## V2500-A1/A5 SERIES PROPULSION SYSTEMS SERVICE BULLETIN

This document transmits Revision 1 to Service Bulletin EV2500-75-0093 and Revision 1 to the Supplement

# V2500-ENG-75-0093

ENGINE – HP COMPRESSOR – INTRODUCTION OF A REVISED HPC STAGE 7A AND 10 BLEED VALVE  
SILENCER WITH INCREASED HEIGHT

Family Tree  
Figure 1

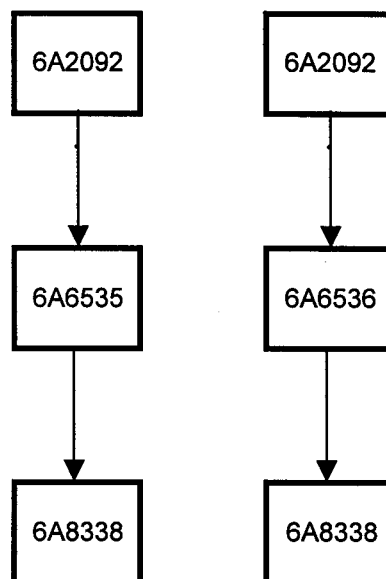
- (a) A revised Stage 7A Bleed Valve Silencer is introduced similar to the existing item except for an increase in height.
- (b) A revised Stage 10 Bleed Valve Silencer is introduced similar to the existing item except for:
- (i) An increase in height.
  - (ii) The existing hole pattern has been changed to facilitate diffusion of the valve efflux.

Engine - HP Compressor - Introduction Of A  
Revised HPC Stage 7A & 10 Bleed Valve  
Silencer with Increased Height.
